Docket Item # 3
BAR CASE #2010-0343

BAR Meeting
July 6, 2011

ISSUE: Signage and alterations

LOCATION: 503 King Street

Figure 7. Proposed wall signs on elevations.

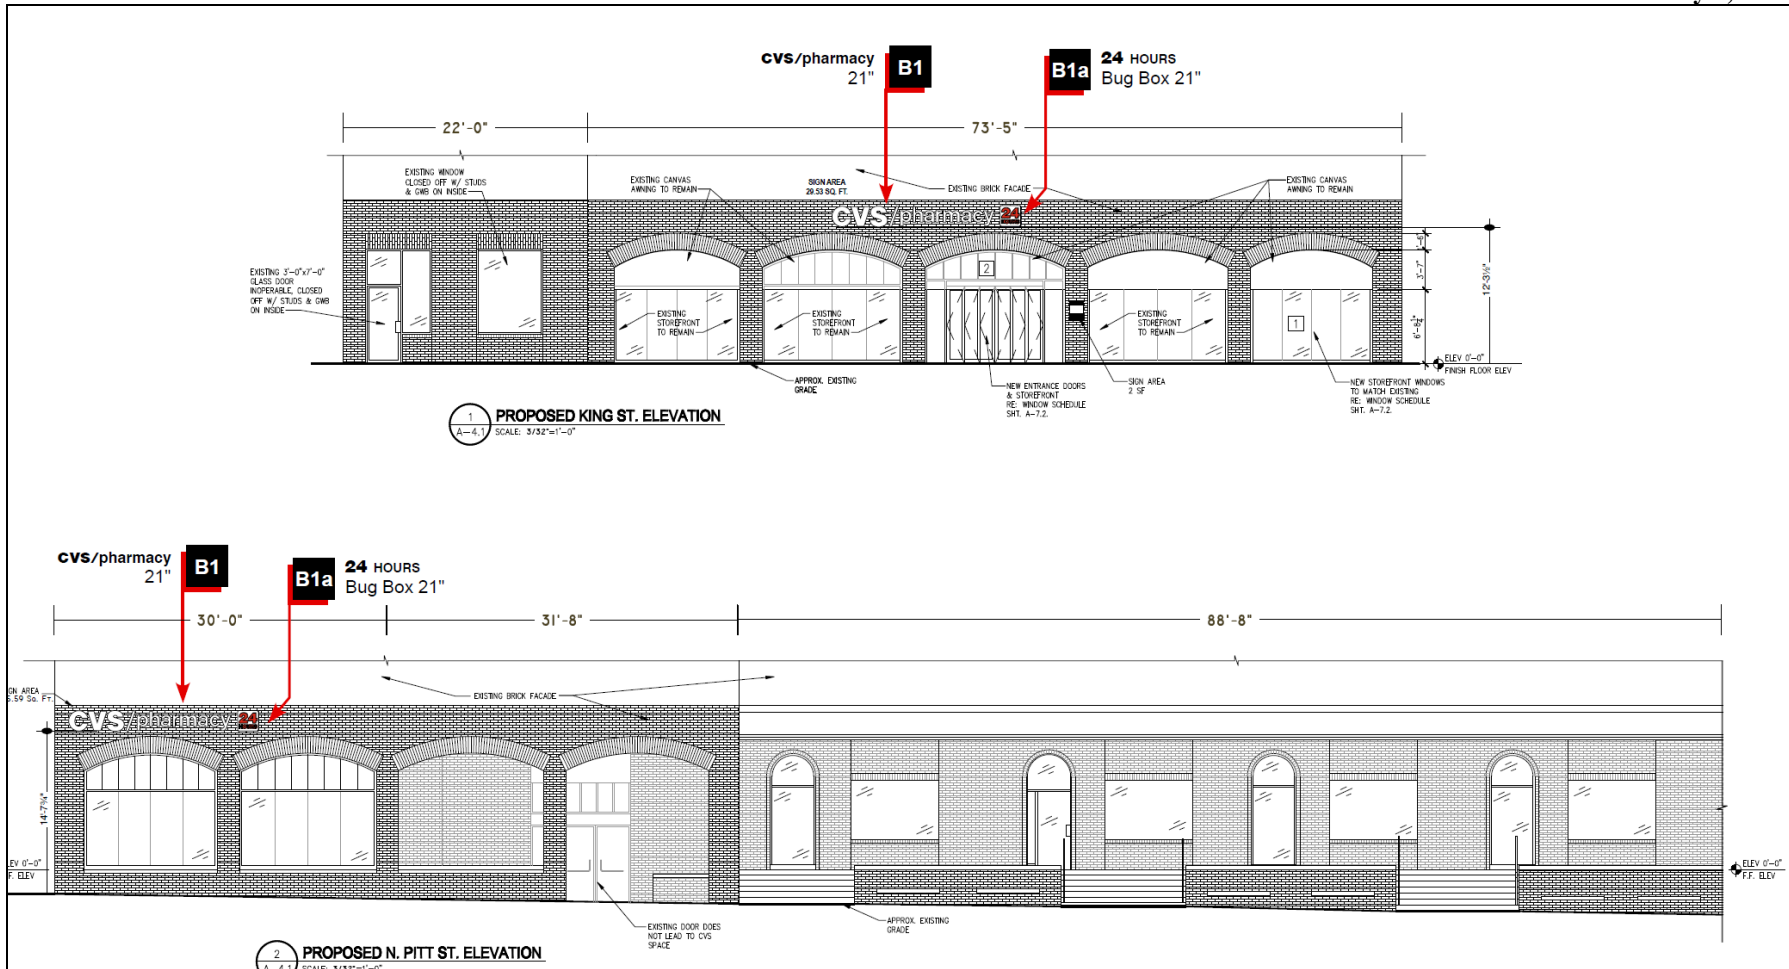
1. That the entrance marquis that was removed not be reinstalled but that a small awning may be installed over the entrance to match the existing awnings over the front windows and that the wall sign proposed on the south elevation be centered above the entrance;
2. That the “Open 24 Hours” signs on the two wall signs and two window decals be removed to be in compliance with Zoning Ordinance requirements;
3. That the two windows on the North Pitt Street elevation at the front corner be left entirely open; and
4. That in the instances where the Board approves obscuring window and door openings, that the applicant utilize historic photographs of this area of King Street prior to urban renewal with final photograph selection to be approved by Staff.

Zoning staff has determined that the proposed “Open 24 Hours” signs (illuminated boxes attached to the two wall signs and two window decals) constitute special advertising. Even if the Zoning Ordinance permitted such signage, BAR Staff would not support these signs due to the proposed method of illumination for the backlit plastic wall signs and the scale of the window decals. Staff finds that unobscured windows will provide open views into the store which will allow the activity within the store itself to advertise the 24 hour nature of this business. In addition, Staff notes that the applicant can utilize the small directory sign adjacent to the entrance to post hours of operation, as other businesses routinely do.

Figure 10. Proposed south (front) elevation (wall sign is not accurate) showing window alterations on King Street.

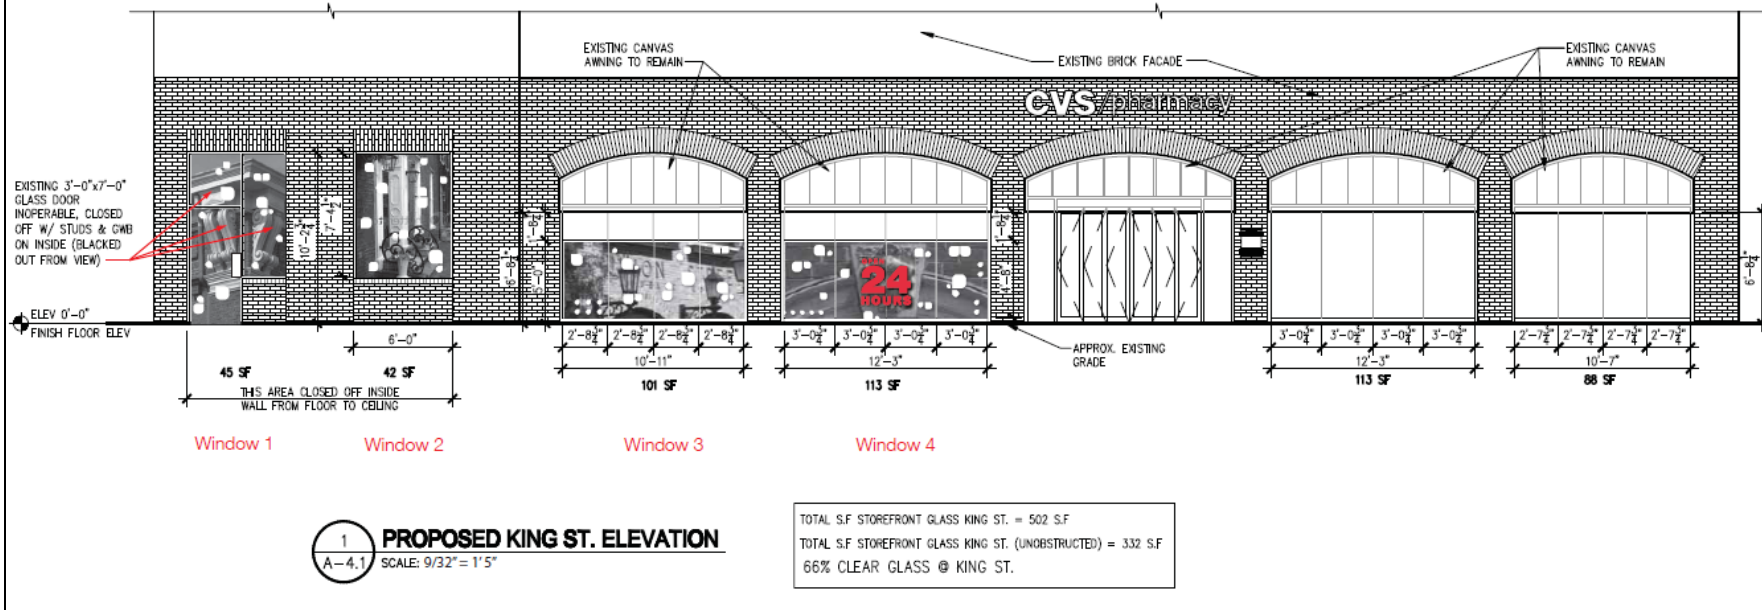
"Windows at the site shall provide open views into the drug store from the street and shall not be tinted, opaque or otherwise obstructed, except as approved by the Board of Architectural Review. Unless otherwise prohibited by the Board of Architectural Review, low-level, well-maintained and regularly updated window displays may be permitted in any windows or door areas approved by the BAR to be blocked."

The *Design Guidelines* state: "Window signs should not obscure the interior view of a retail establishment. Windows should not be painted, inappropriately tinted or otherwise made opaque." Several national retail chains are located throughout the historic districts. However, in many circumstances the corporate package is modified so that signage and alterations are compatible with the character of the district. Some recent examples include the Walgreen's on King Street and the expansion of Trader Joe's on North Saint Asaph Street. In addition, the King Street Retail Study recommends that at least 70% of the windows at the first-story remain clear glass. The study recommends that windows have easy-to-understand and uncluttered displays that regularly change and allow a view into the rest of the store.

BAR Staff met with the applicant's team on two occasions and has provided ongoing consultation on the design over the past several months. Staff has maintained that the windows should remain clear and open to the maximum extent possible. As with the previous store layout at Books a Million in this location, BAR Staff requested that the applicant restudy the internal layout of the store to minimize the windows to be obscured. In an early scheme the applicant had proposed covering all windows and doors except for two windows and two doors. The applicant relocated the coolers proposed for the front corner farther into the store to reduce the area to be covered at this important corner location. Staff recognizes that there are certain areas where portions of windows and doors must be covered, such as behind the cash register and adjacent to storage areas. Although the applicant has somewhat reduced the windows to be obscured, Staff continues to maintain that the windows at the highly visible front corner, where the travel agency was formerly located, be entirely clear. This front corner is an opportunity to add vibrancy to the streetscape and clearly show customers and merchandise. While Staff would prefer to have the remaining windows on the North Pitt Street elevation entirely unobscured (with the exception of the one covering a storage area), Staff finds that these generally are set back and have less of a street presence. During meetings with the applicant, Staff emphasized that in the locations where windows must be covered, the applicant should use historic photographs of this area of King Street, rather than blown-up contemporary images of nearby buildings, as they originally proposed. These interpretive historic photos may be considered "art" in the zoning ordinance, rather than signs.
